SUPPLEMENT TO A REPORT BY THE
Comptroller General
OF THE UNITED STATES

Issues Concerning The Department Of Energy's Justification For Building The Gas Centrifuge Enrichment Plant

GAO/EMD-82-88S
JUNE 24, 1983

Figure 1
GCEP Benefit
(Net Present Value 1983-2010)

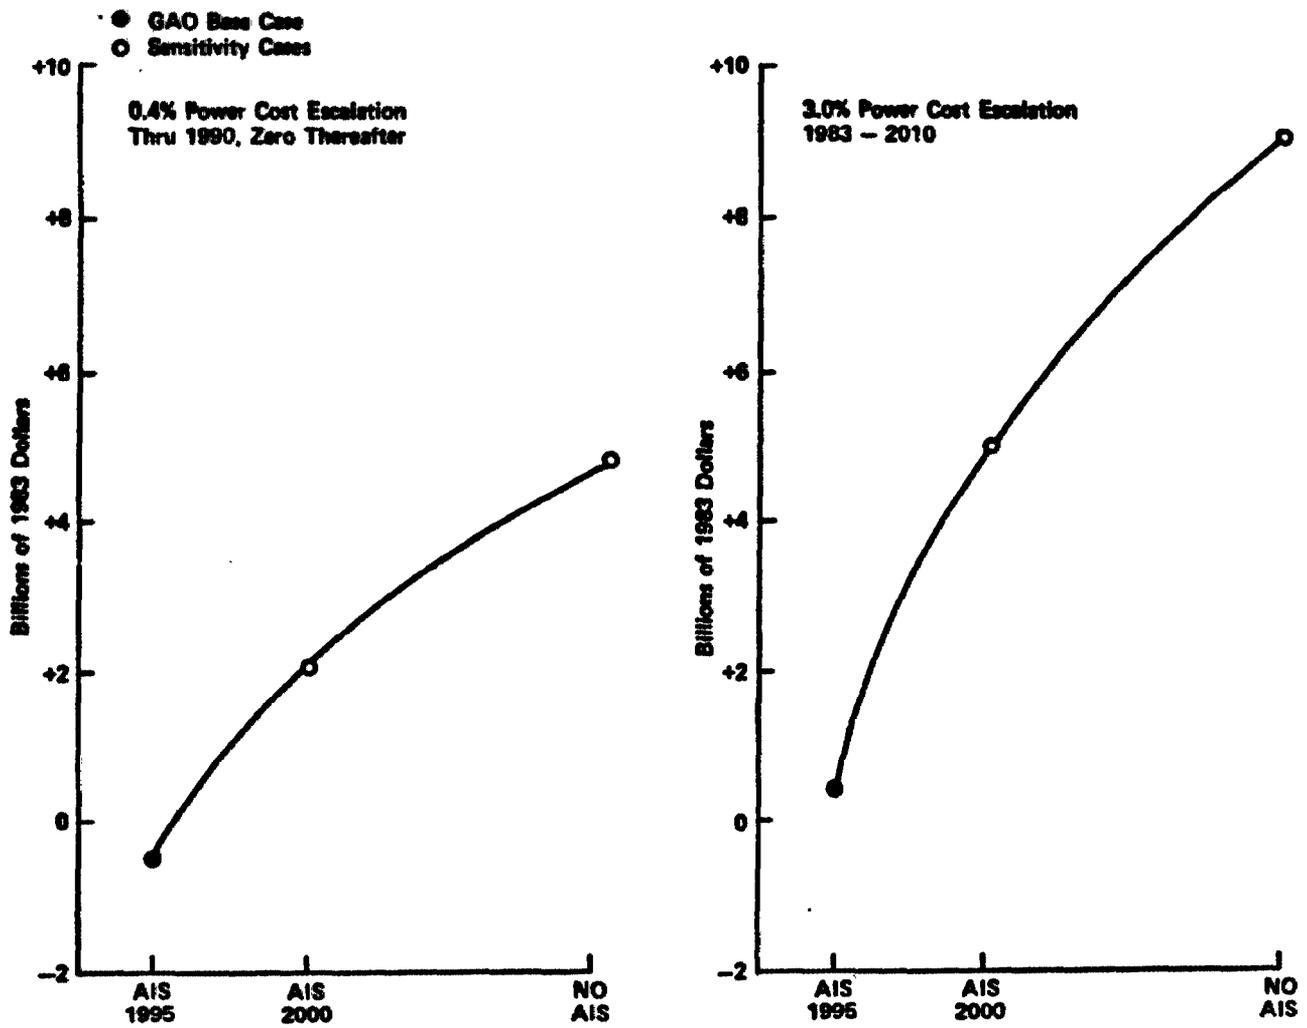
- a Power costs are also significant risk factors. As shown in Figure 1, a higher power cost escalation of 3.0 percent eliminates the AIS advantage and results in a greater benefit for completing GCEP. The GCEP benefit increases from \$0.4 billion if AIS is on schedule, to a benefit of \$5.0 billion if AIS is delayed 5 years. While DOE believes that 3 percent power cost escalation is on the high side, this comparison demonstrates the sensitivity of the results to this parameter and quantifies the large risk that would be assumed if GCEP is not built. As shown in Figure 1, GAO selected a very biased set of assumptions and presented this "tip of the iceberg" as a basis for making a decision on GCEP. Underlying their analysis is a large matrix of risks that could result in significant costs to the Government and DOE enrichment services customers.
